CITY PLAN COMMISSION STAFF REPORT

Project Name
Plaza East Apartments

Request
CD-CPC-2022-00192
Development Plan - Residential

Location 1500 E. 46th Street
Area About 20.6 acres
Zoning R-1.5
Council District 3rd
County Jackson
School District KCMO 110

OVERALL SITE PLAN

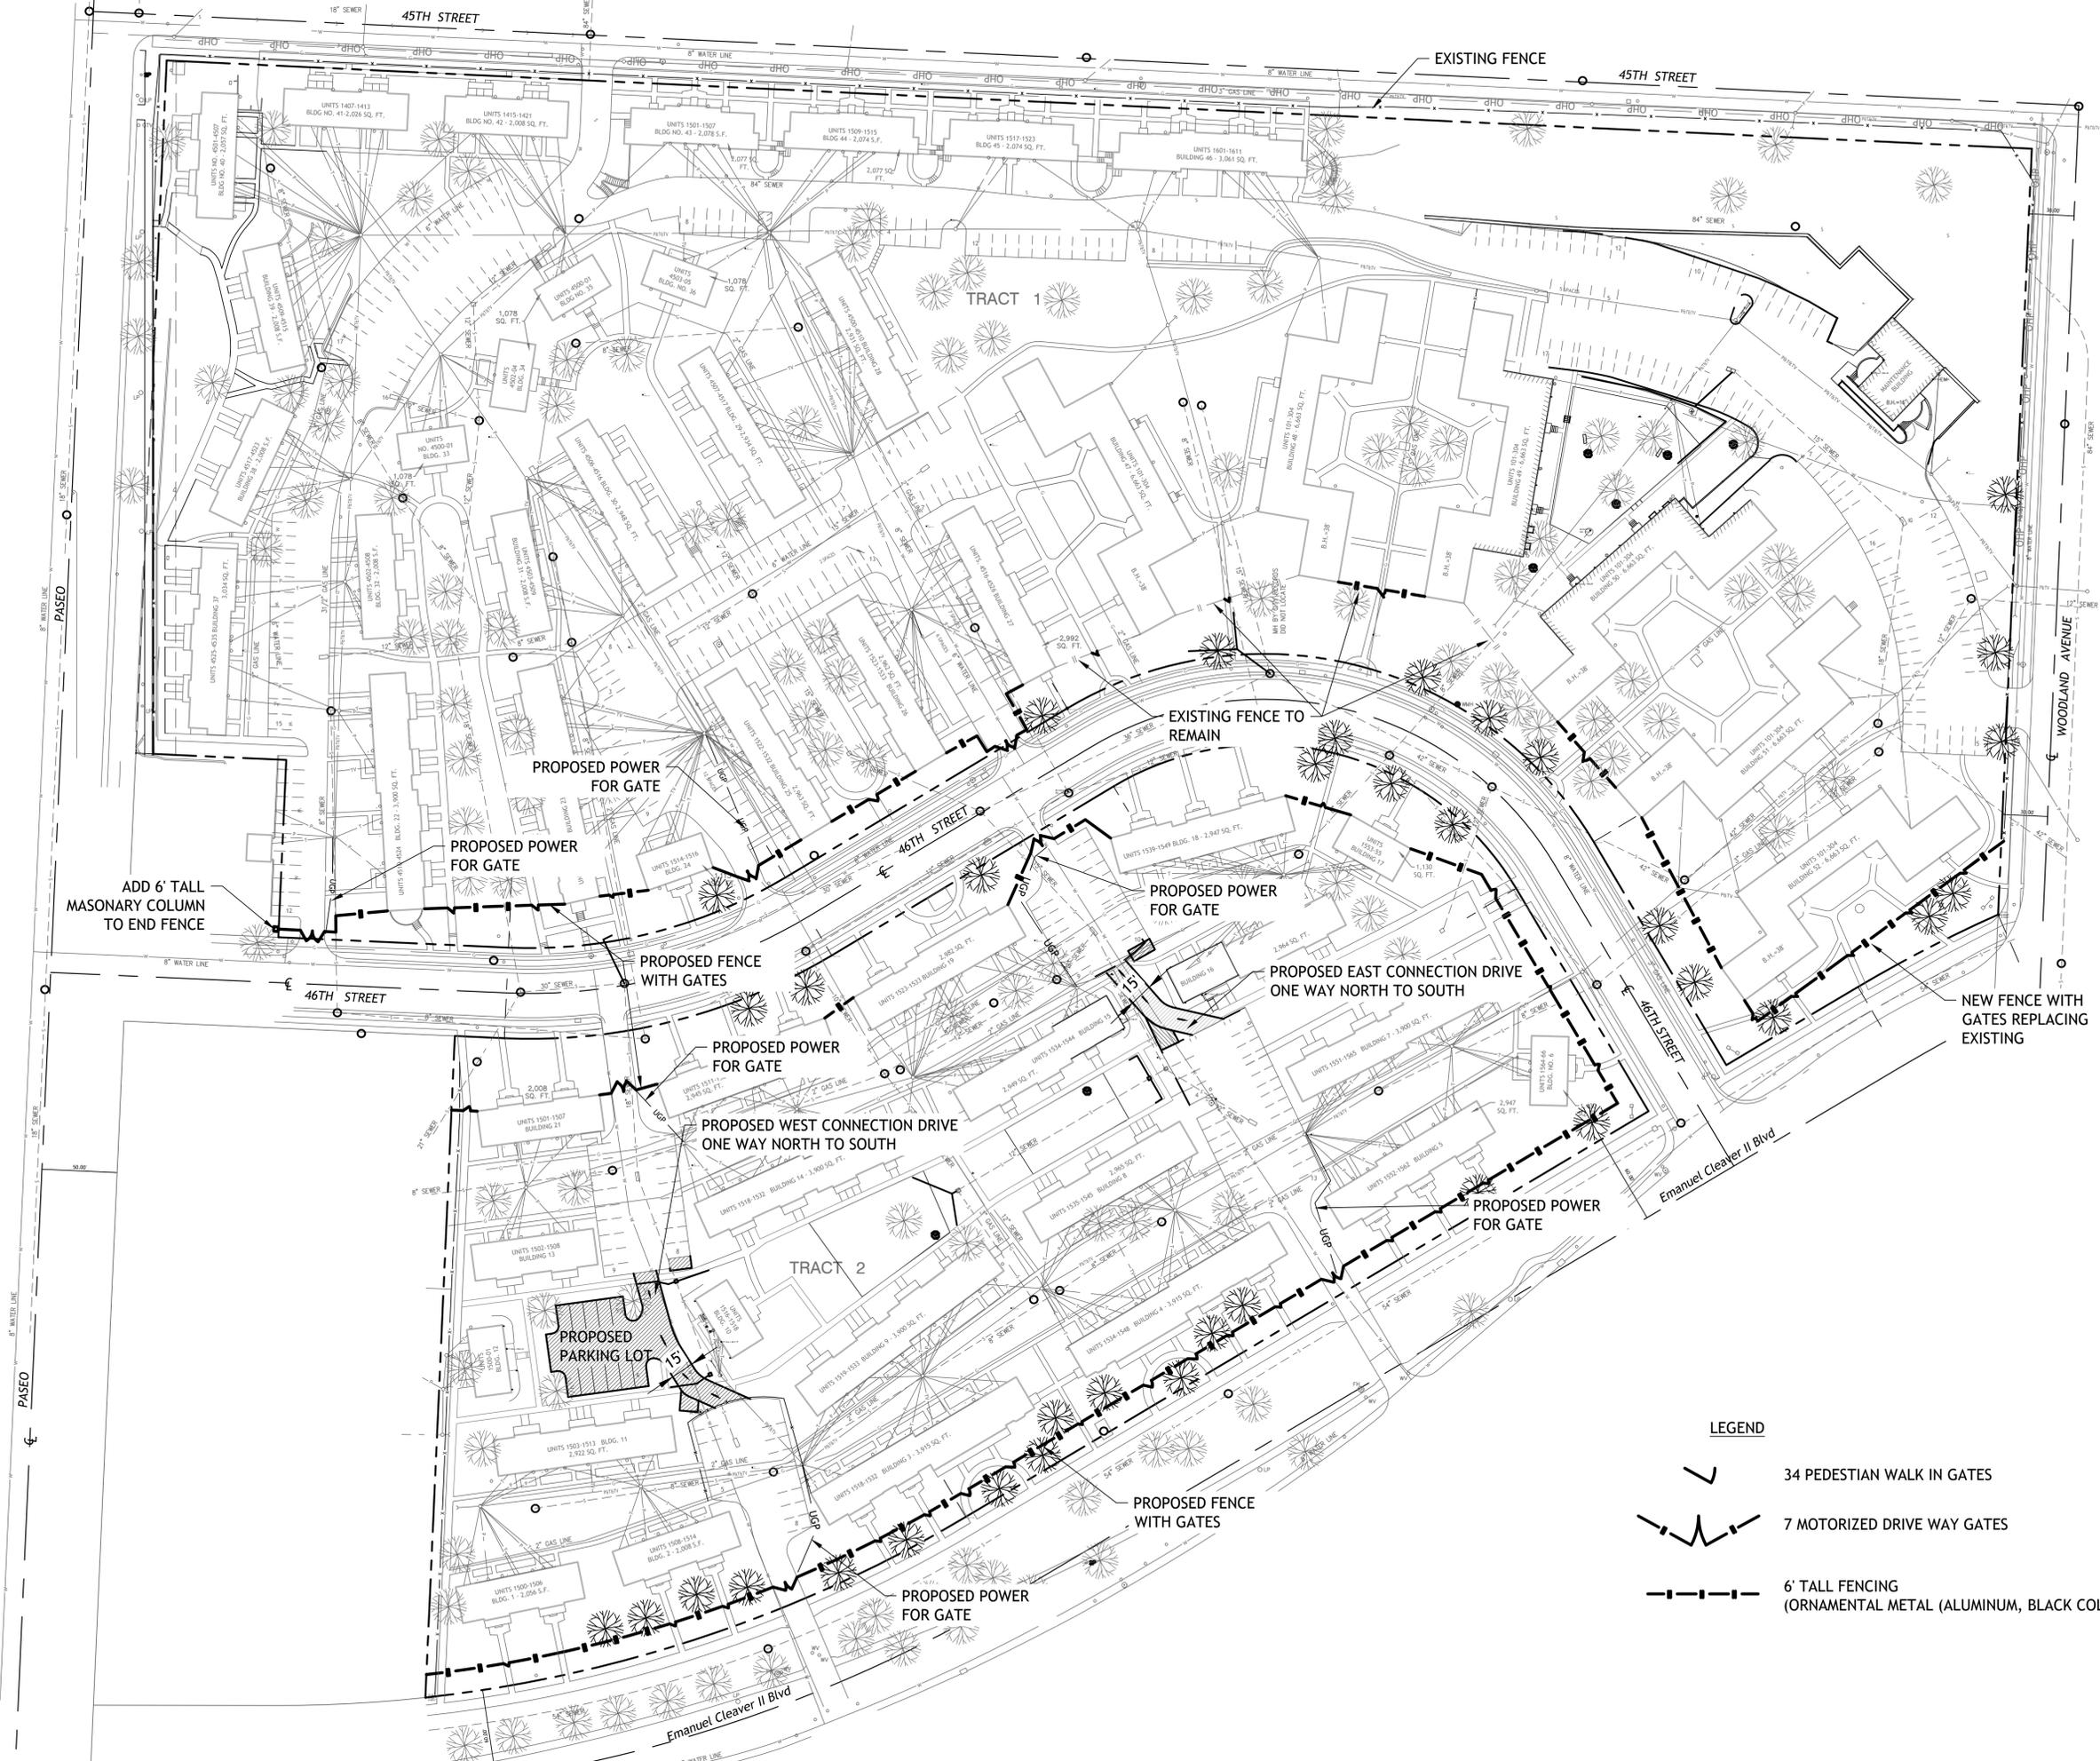
6. Security gates which span across a fire access road shall provide a means for emergency operation. Electric gates shall require a siren sensor device typically referred to as a "yelp gate" (IFC-2018 § 503.6).

LANDSCAPE PLAN

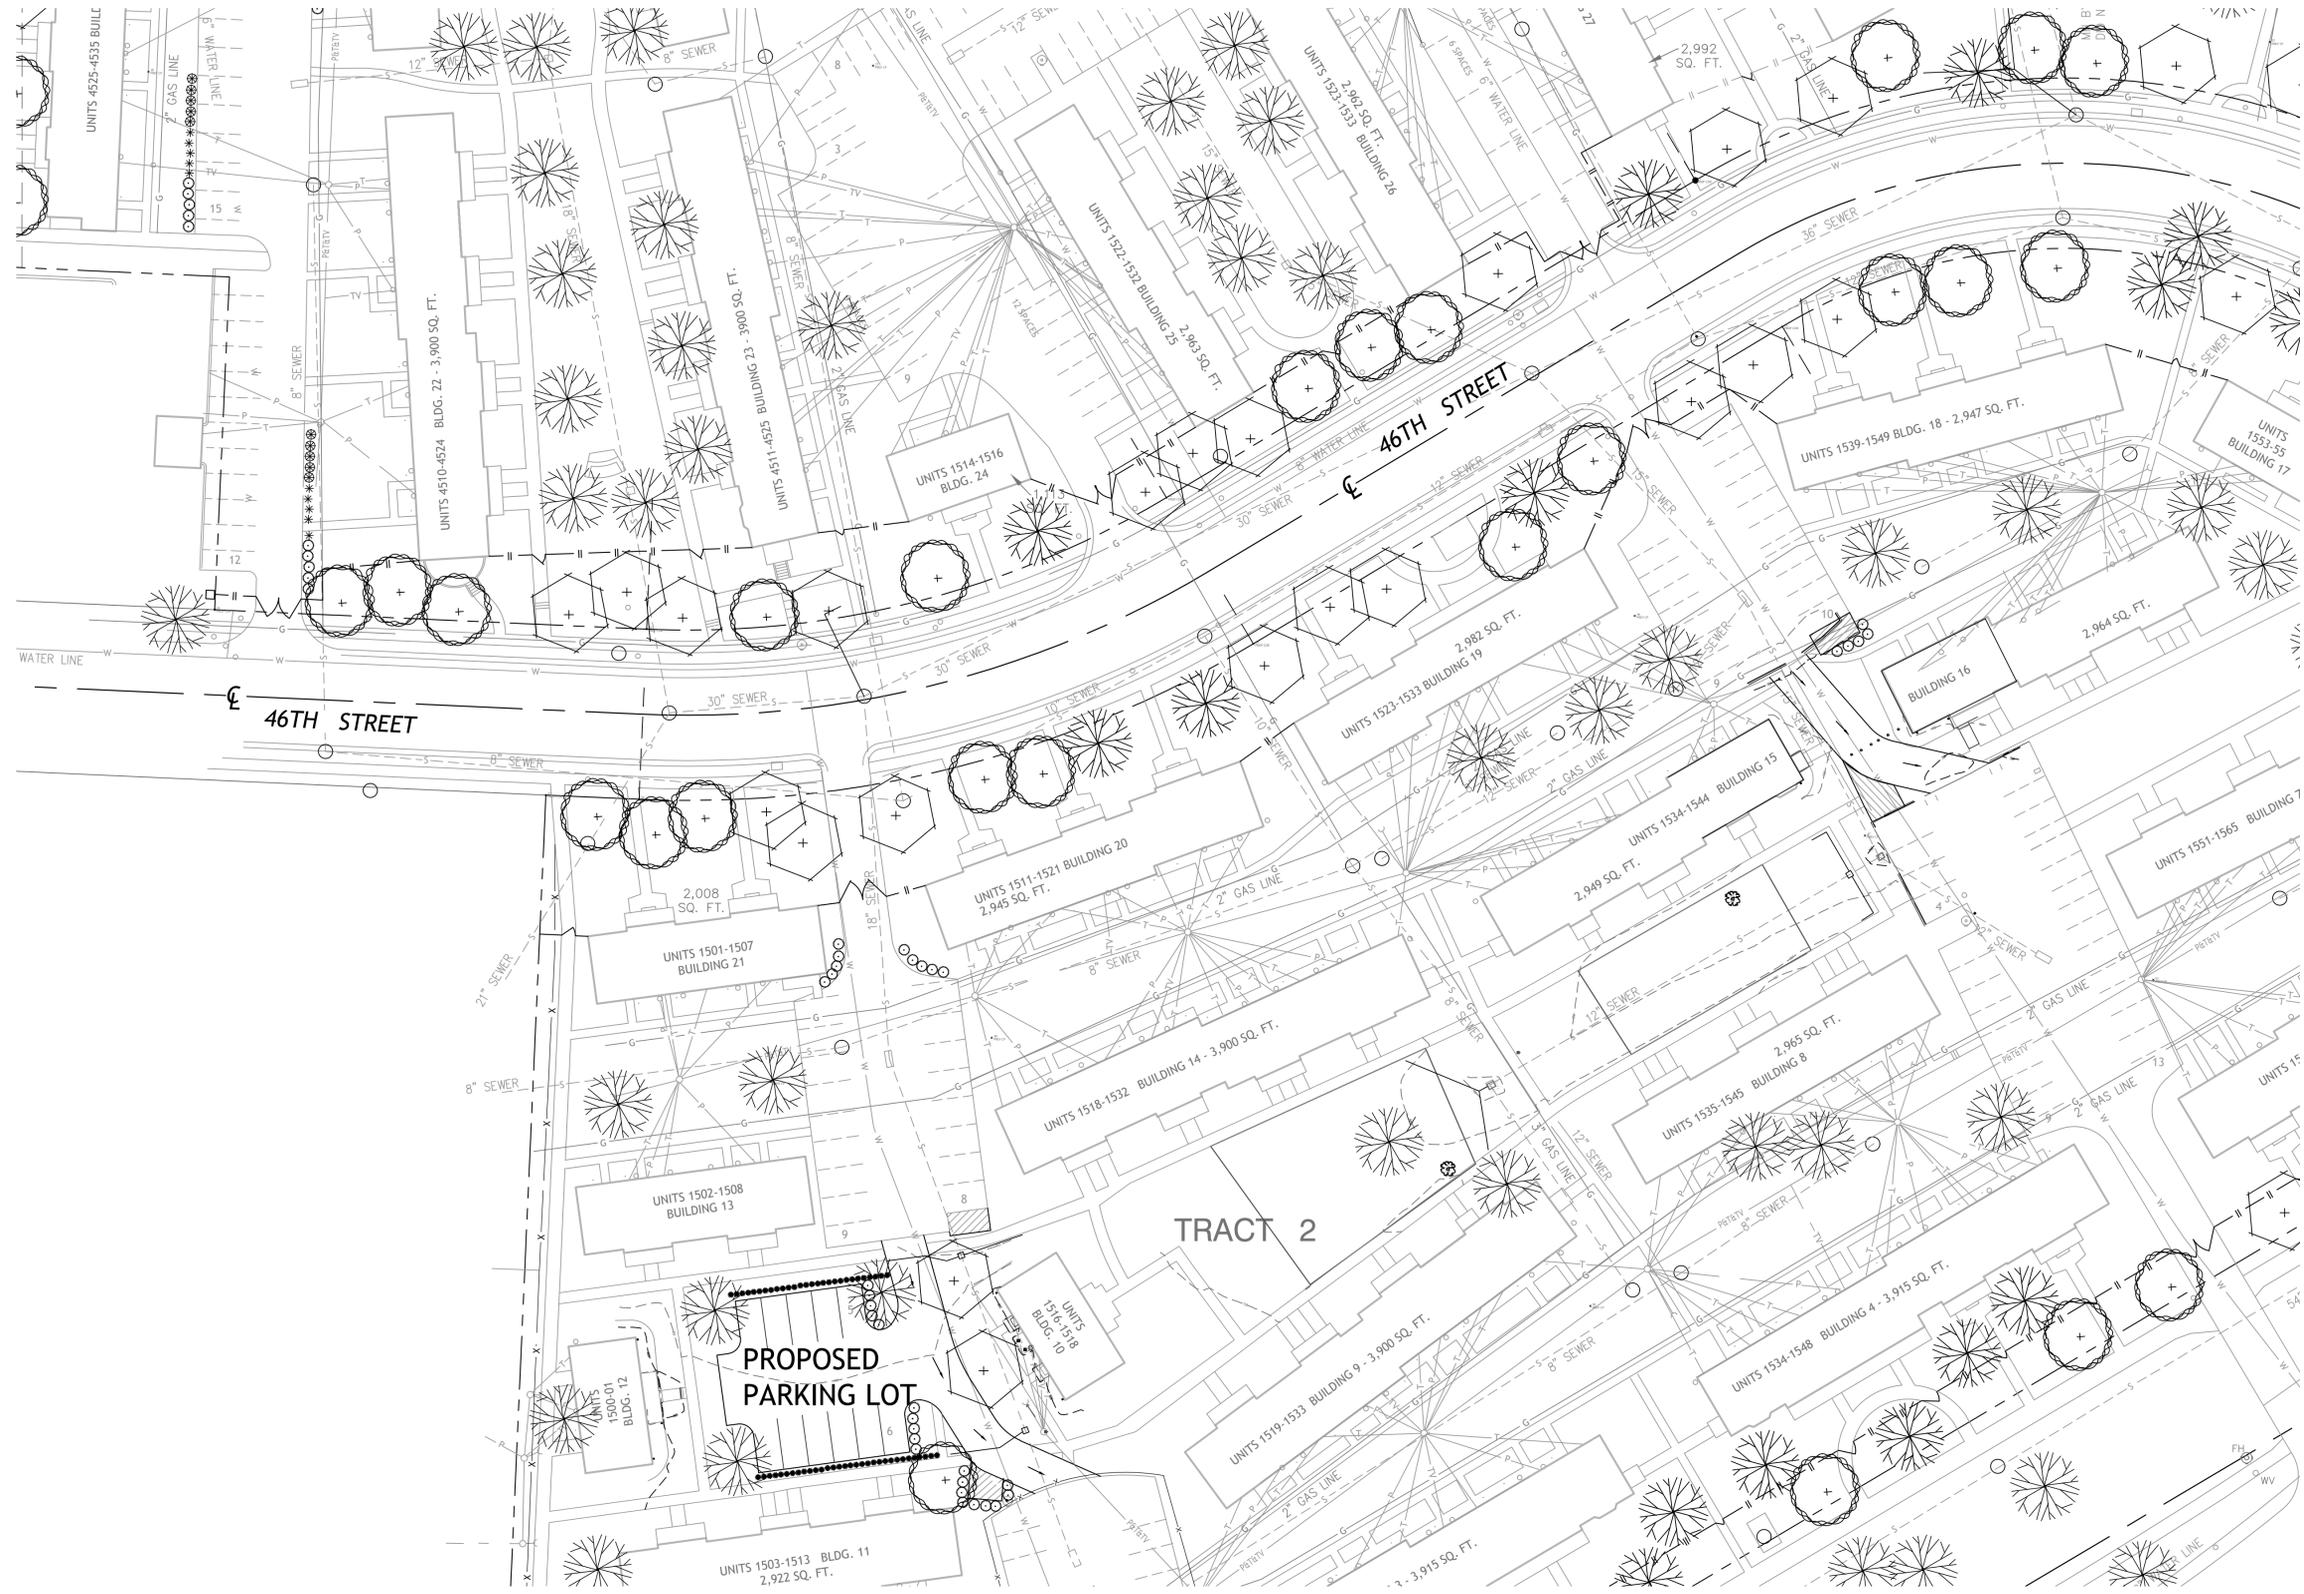
4. That all signage shall conform to 88-445 and shall require a sign permit prior to installation.
5. Prior to ordinance request the developer shall revise the landscape plan to remove and replace all invasive species.
